Responses to Letter No 633		
Author	Main Concern/s	Relevant Response
	1-b) Land loss due to noise pollution: The complaint elaborates further on the land loss due to wind turbine noise. Referring to phase one extension project EIA, it is stated that the noise generated from the wind turbines will disperse up to a distance of 300m losing approximately 70 acres of land (perhaps referring to land area that could otherwise be occupied by the people) showing the severity of loss of (habitable) lands due to all wind farm projects. 1-c) Land limitation in Mannar island: As Mannar is a low-lying area prone to inundation only a limited extent of land is available for human settlements. The proposed 250 MW wind project EIA has failed to address this critical aspect highlighting the need for further impact evaluation on cumulative, different dimensions and long- term impacts.	1-b) Land loss due to noise pollution: In the present EIA the noise analysis (Conducted by ITI which is an accredited government institute) shows that (Refer Table 4-5) only in 8 turbines there is a marginal noise exceedance (equal and above reference level 45 DB for night time, the noise levels at the 8 turbine location

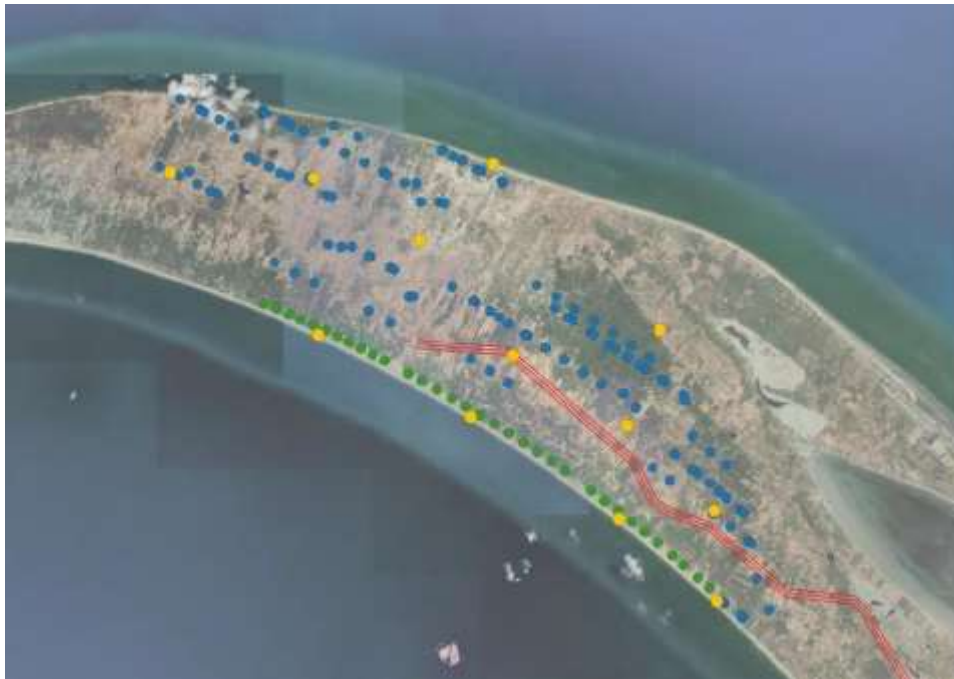
Q 1.1.c: Furthermore, the Environmental Impact Assessment (EIA) did not address the critical migratory period of birds during the study, resulting in the oversight of substantial bird movement. Consequently, the observers failed to witness the large-scale movement of birds, particularly since resident birds in Mannar typically do not exhibit the same flocking behavior as migratory ones.

R 1.1.c: *Responding to this comment is truly a waste of time when the commentators have miserably failed in their duty to read the report. It has been clearly stated in the EIA (Sections 3.4.6 and 4.3.2) that the bird survey was done for a period of a year. See also response No. 4.*

Since majority of the birds move along the coast it is inevitable that fewer numbers would be travelling through the Mannar island as was confirmed by the daytime surveys. The aerial corridor has been provided to facilitate movement of birds between the congregational areas on either side of the island. See response 8.

Figure 3 Map showing proposed and existing wind farms in Mannar area

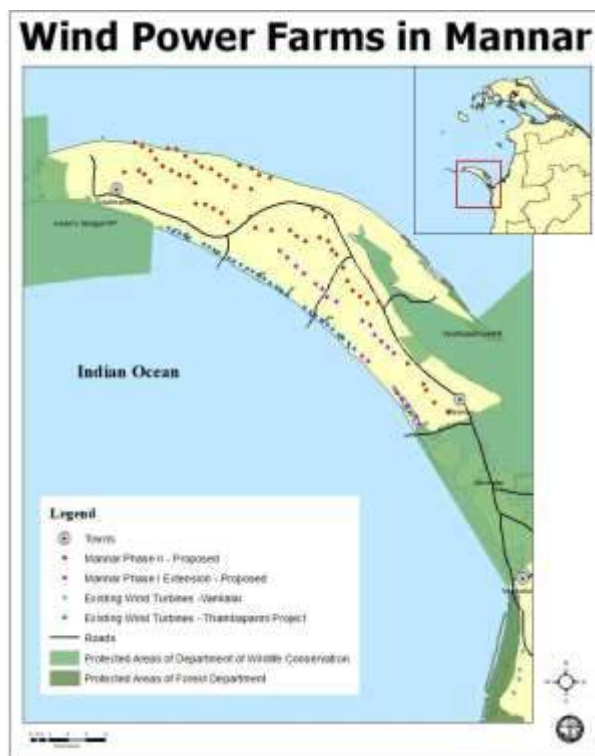
Q 1.3.5: As a Range State for the CAF under CMS endorsed Action Plan for waterbirds and their habitats in 2005. The Country report tabled in 2005 by the Department of Wildlife Conservation the focal point for CMS establishes Mannar and the Palk Strait region as an important entry point for migratory birds.

Vankalai Sanctuary was declared as a Ramsar site in 2010 and harbours a combination of coastal and marine integrated wetlands and coastal landscapes (e.g. sand dunes) that provide habitat for many waterbird species. During a waterbird census conducted between 2011 and 2017, more than 100,000 waterbirds were seen at three different instances in Mannar region, where the study sites consisted of Vankalai, Vidattaltivu and Erukkalampidy. Amongst a myriad of other criteria, one of the main criteria to meet for Ramsar recognition is the ability to support well over 20,000 waterbirds at a given time. Mannar region supports well over that threshold and therefore, is a critical wetland complex of international importance. In designating a Ramsar site, a Contracting Party commits to maintaining its ecological character. In the face of adverse risks, countries are required to report any actual or potential adverse human-induced changes in a Ramsar Site to the Secretariat. As such, the Ramsar focal point of Sri Lanka (i.e. DWC) should be held answerable and take preventive action to minimize the threats to the Vankalai sanctuary arising from the proposed wind power plant development.

R 1.3.5: The wind power plant is away from Vankalai Sanctuary. And the Project area is not a Ramsar site. It is true that some turbines are in the buffer zone of Vedathalaithivu Nature Reserve. Such proposals are not illegal as the EIA is subjected to the approval of DWLC.

Figure 5 Locations of Surveyed Areas

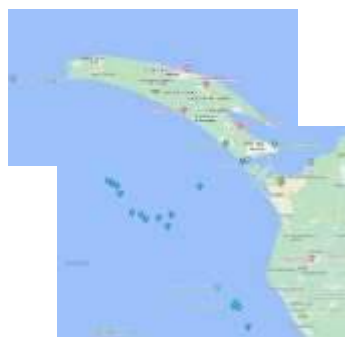
The report indicates the use of cargo ships or large barges for the transportation of wind turbine blades to the jetty proposed to be built in the south side of Mannar. Based on a survey conducted by The Pearl Protectors in Vankalai, Silavathurai and Arippu reef areas, the median depth of the shallow water seabed was 2.5 meters.

Dating in September and October 2023, The Pearl Protectors conducted a series of surveys to ascertain the impact caused by ALDFG (abandoned, lost, discarded fishing gear) in the South Mannar area, during the surveying, 20 areas were surveyed to understand the depth, the marine eco system and the prevalence of ALDFG. Figure 1 shows the areas the surveying was conducted.

Figure 7 Average draft of a large barge

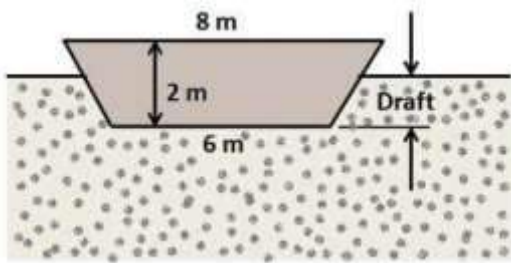
Extensive surveying is required to determine if any deep-water path is available to the jetty to maneuver the proposed barges and tugboats to the proposed location. If the surveying fails to

determine any deeper water pathways, we recommend abandoning the construction of the proposed jetty in the South Mannar location.
